## Chapter 2 TEXT CHANGES

### 2.2 TEXT CHANGES

FIGURE 2-5a  
Common Open Space Diagram

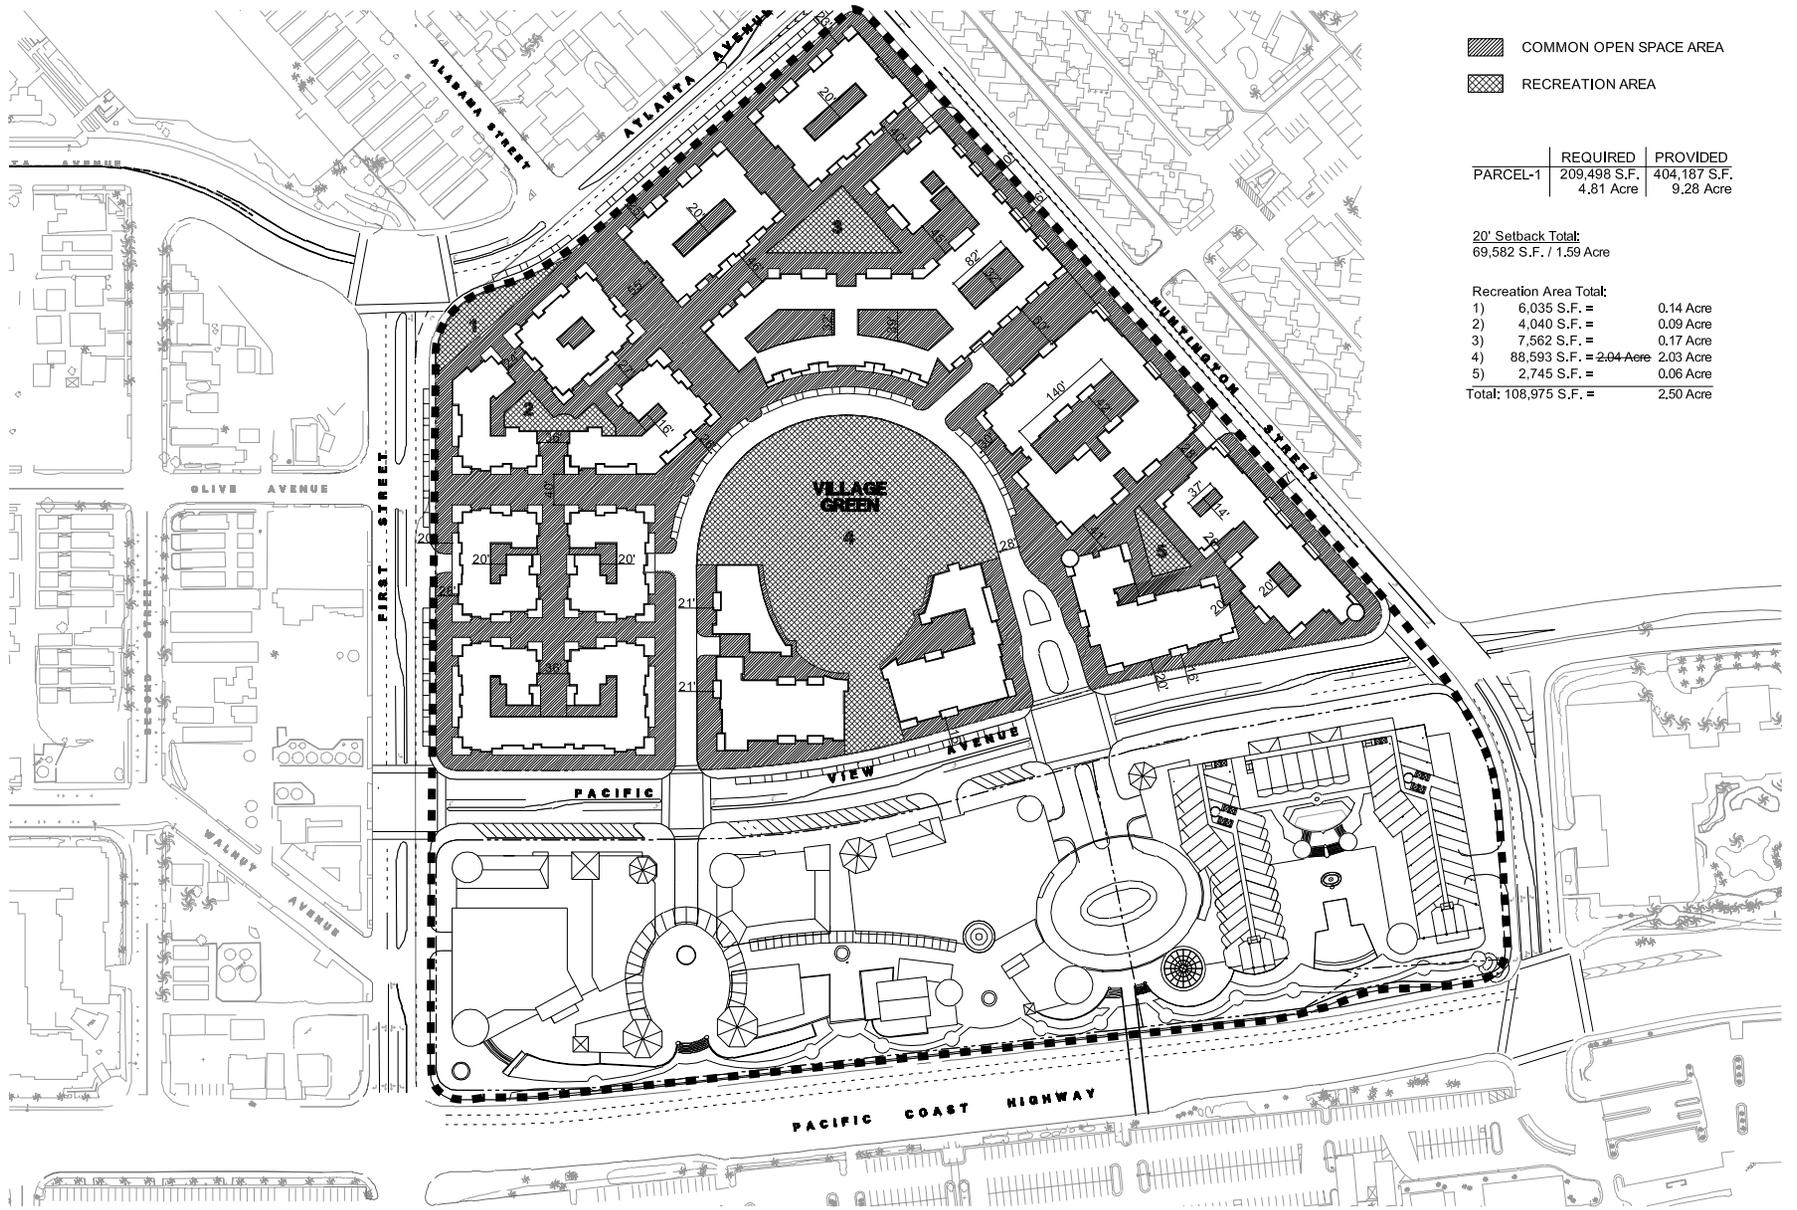
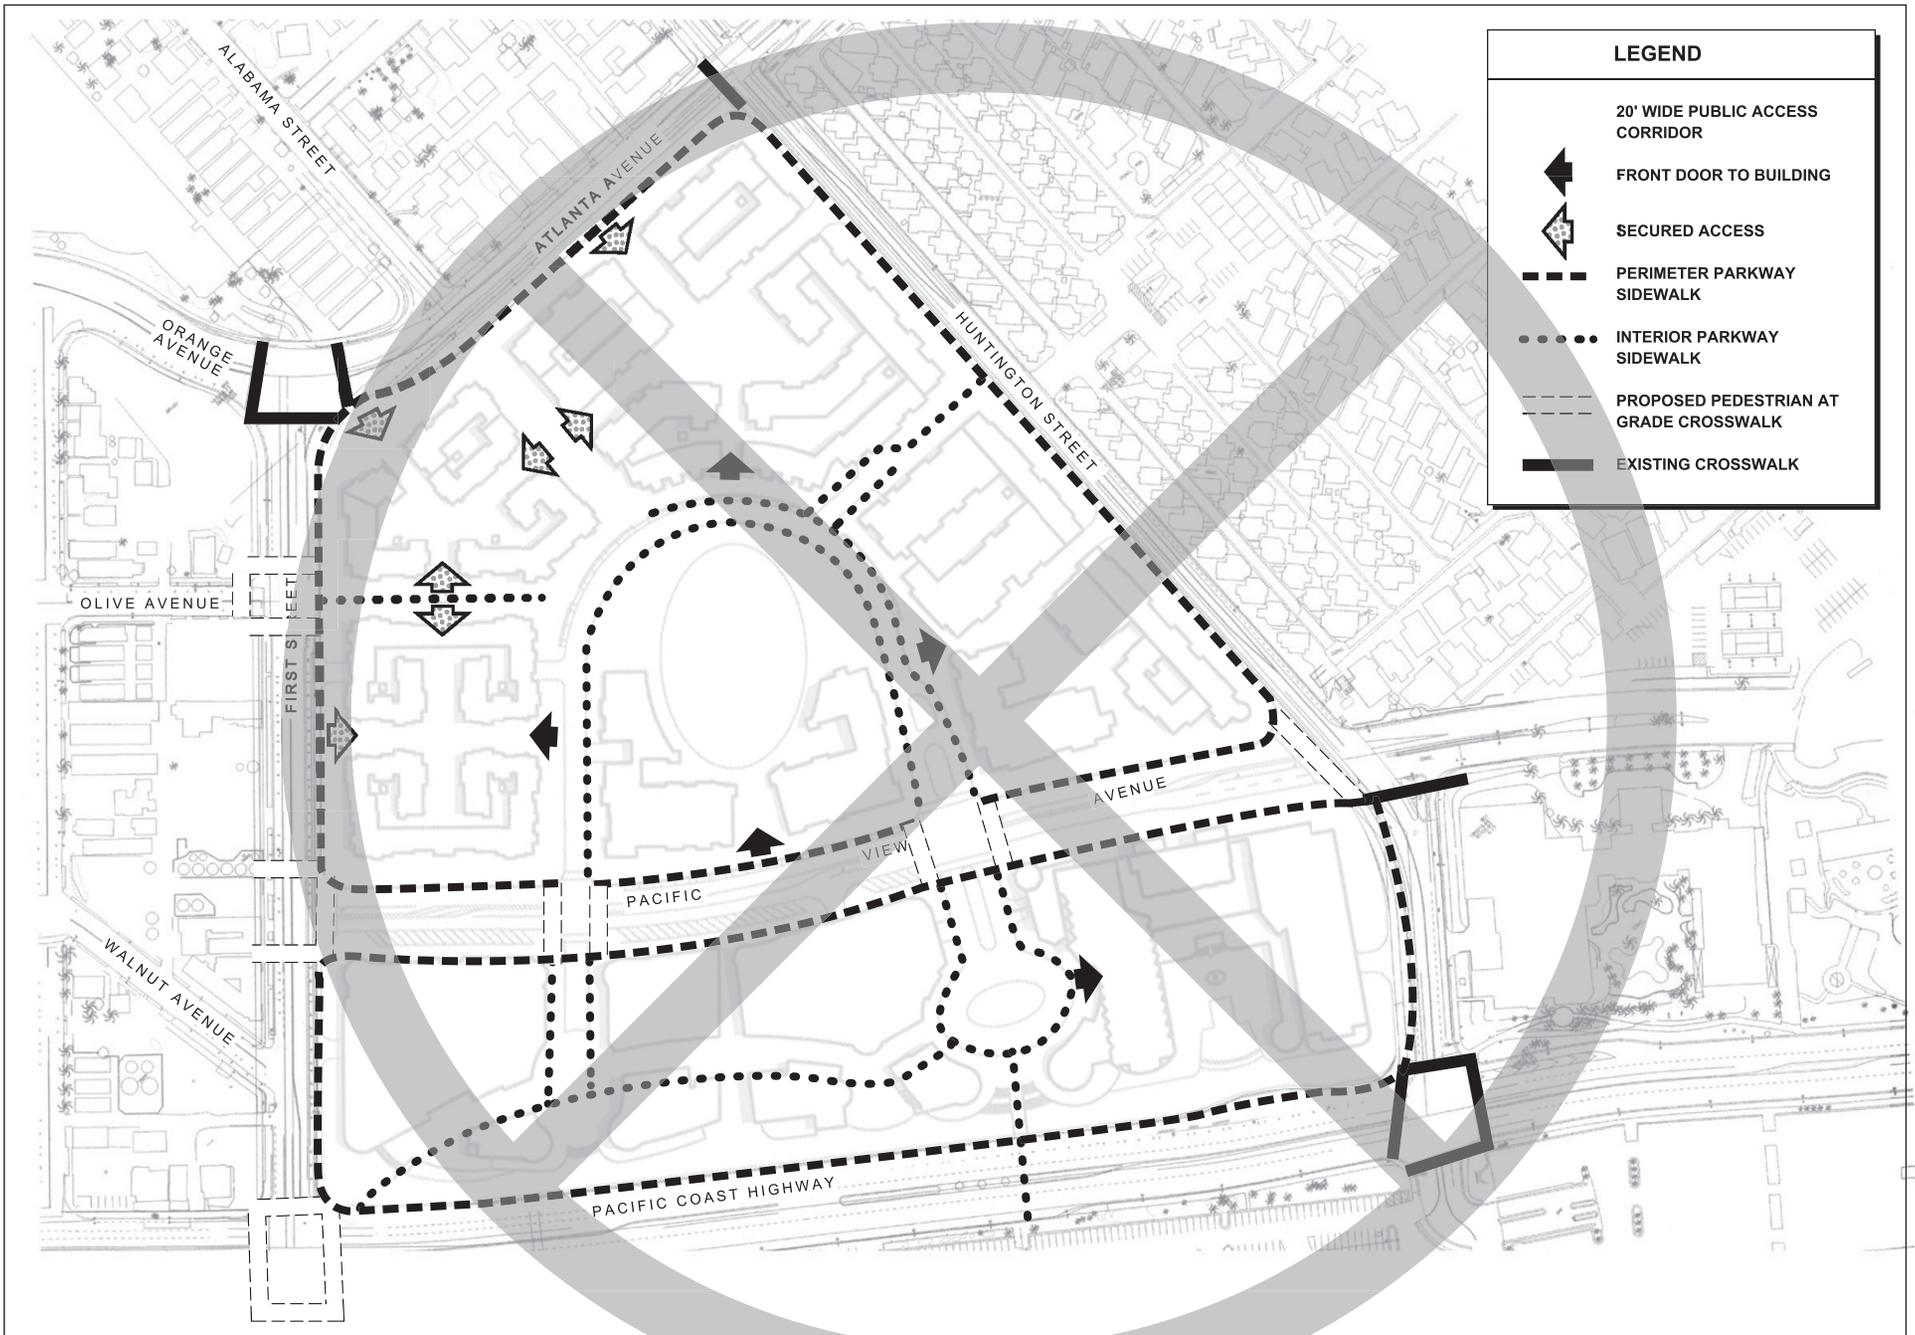
- Figure 2-5a Common Open Space Diagram
- Figure 2-7 Pedestrian Access and Circulation
- Figure 3.9-1 Land Use Map

FIGURE 2-7  
Pedestrian Access and Circulation

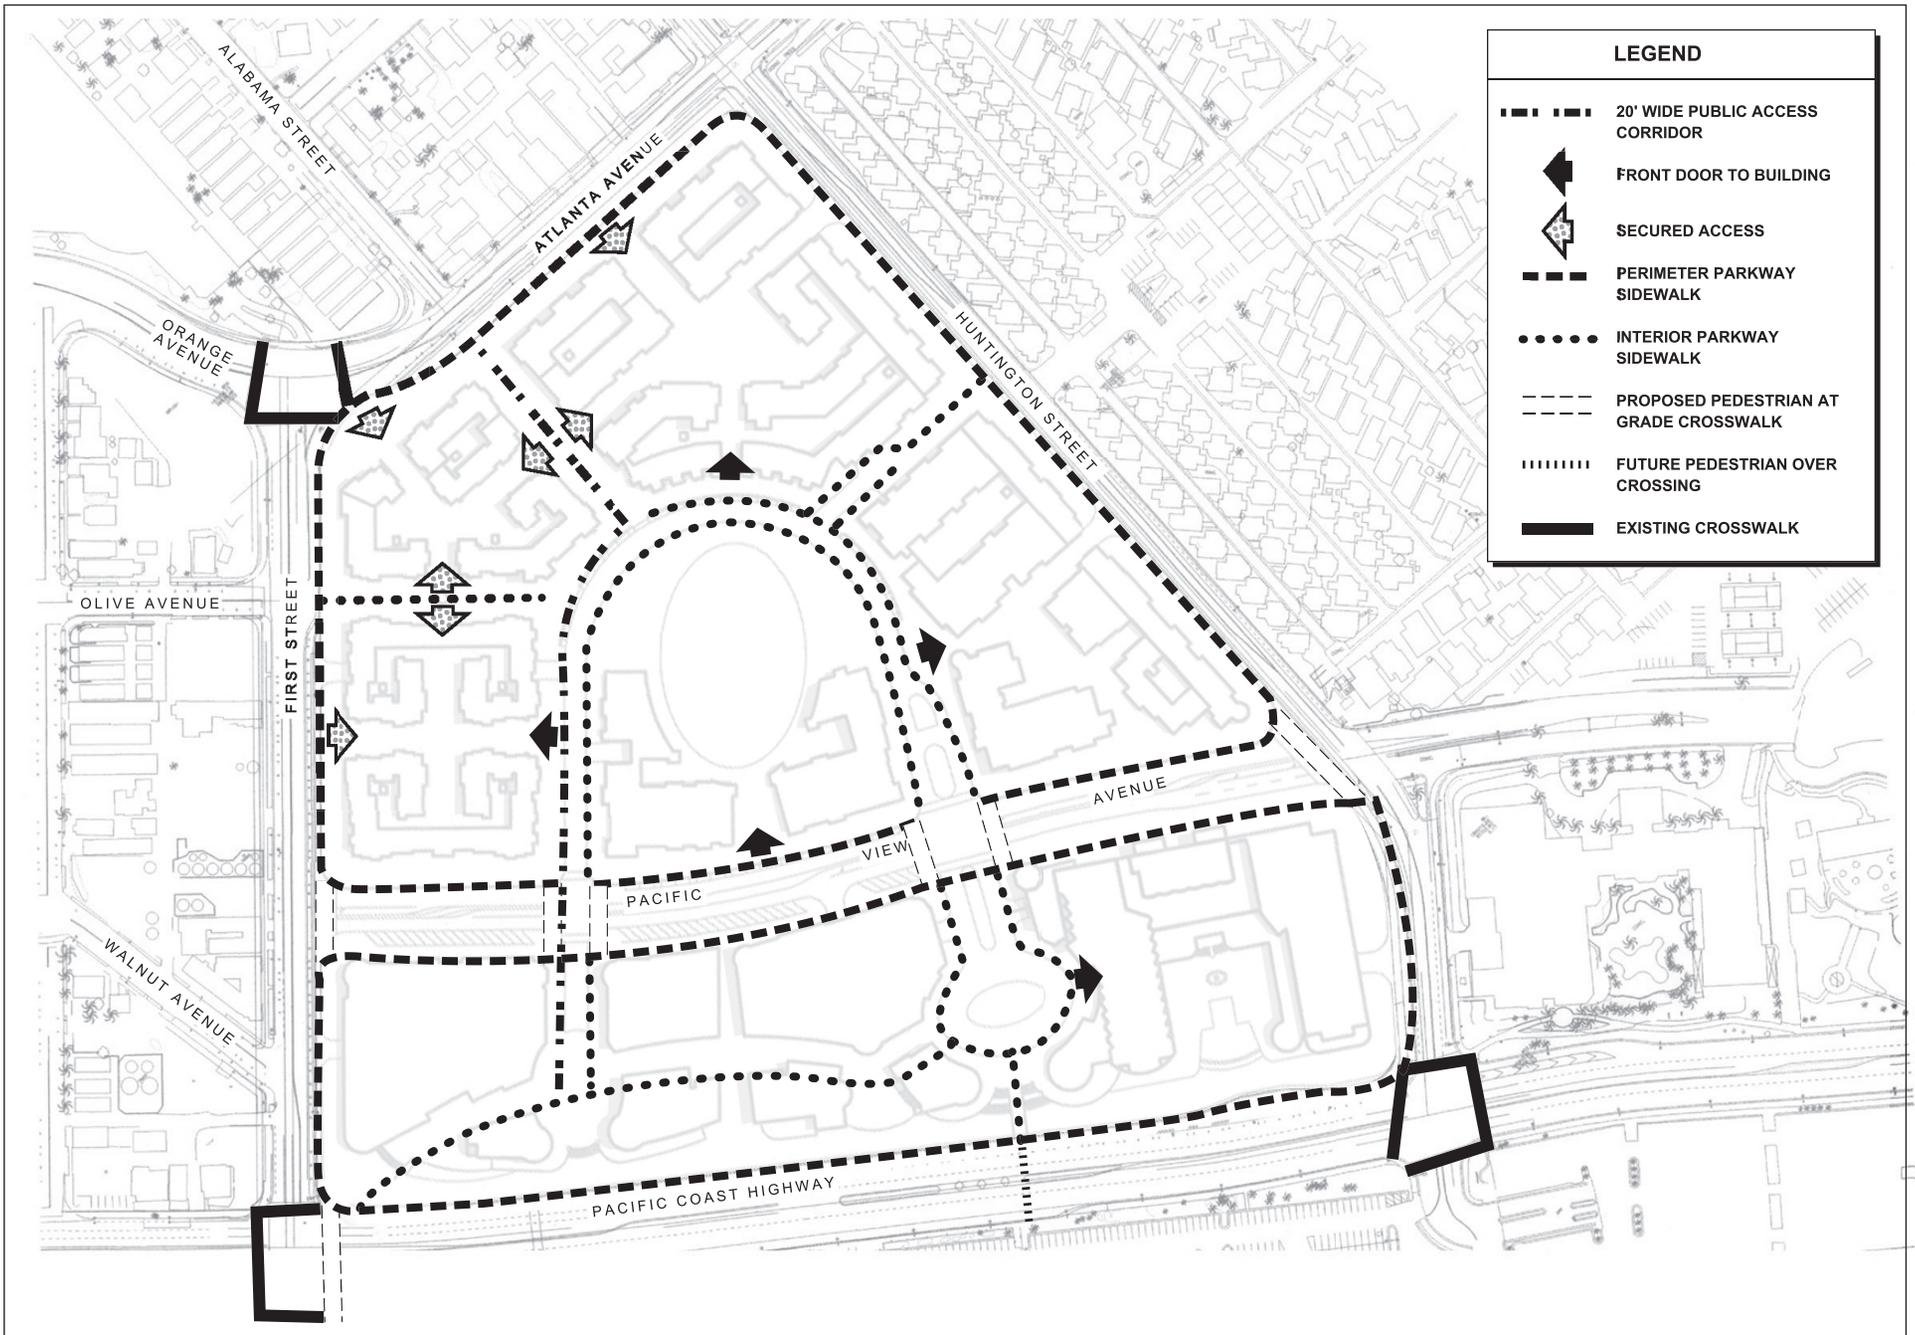
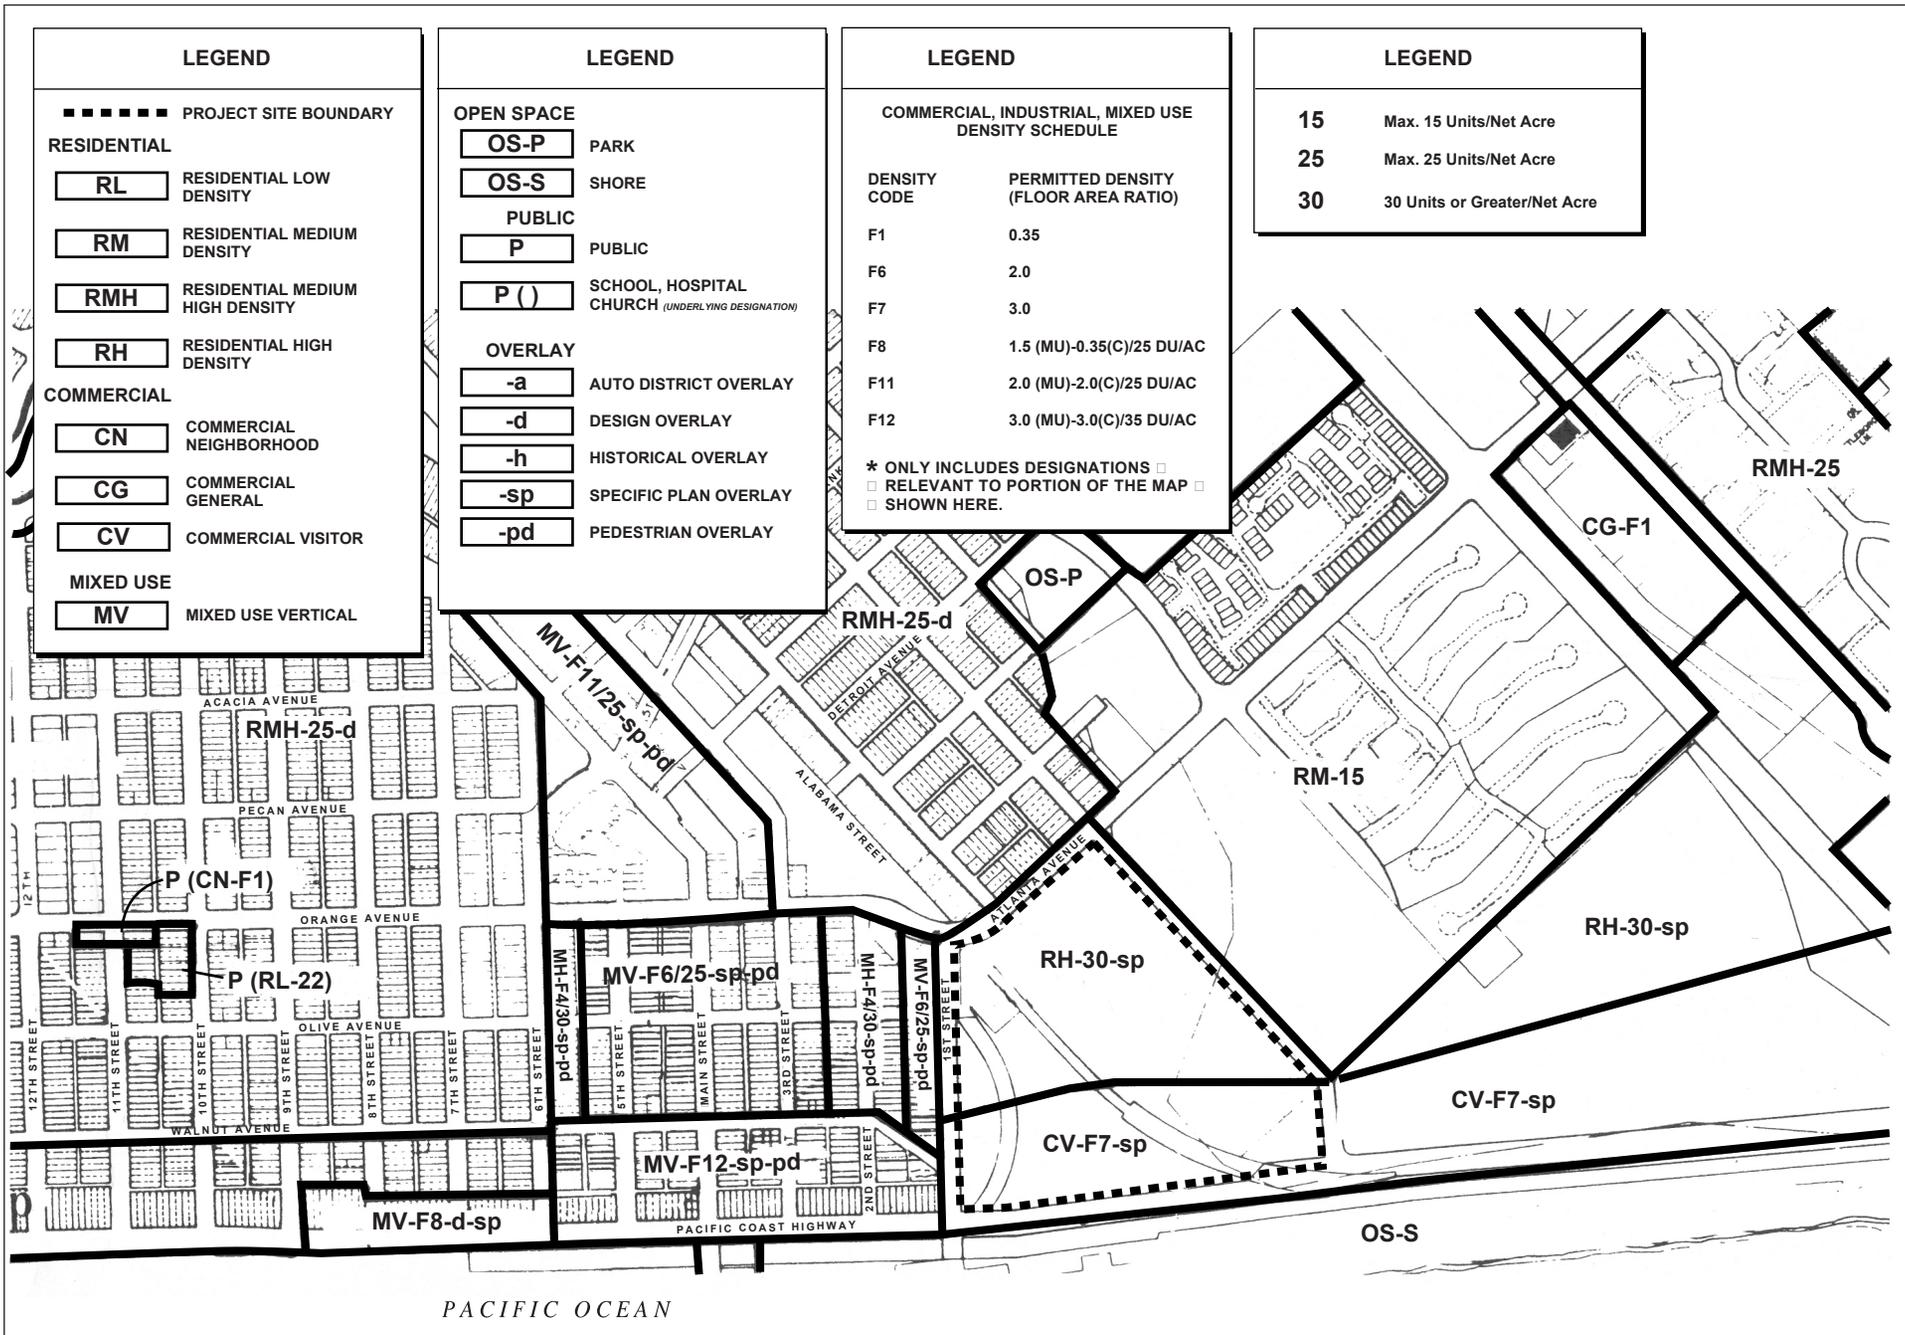
Pedestrian access improvements include pedestrian corridors throughout the project site (Figure 2-7). Pedestrian pathways would link the surrounding residential communities and the proposed residential component, and would be publicly accessible at all times. These pedestrian access ways would then connect to the commercial component and PCH and, ultimately, to the beach parking lot.

Pedestrian corridors would also be provided throughout the project site, as shown in Figure 2-7. Pedestrian pathways would link the surrounding residential communities and pathways, including the public access corridor that commences on Atlanta Avenue and aligns with Alabama Street (oriented perpendicular to Atlanta Avenue). In addition, as mentioned previously, four pedestrian paseos would provide access to the proposed "Village Green." These would include (1) pedestrian access from First Street aligned directly
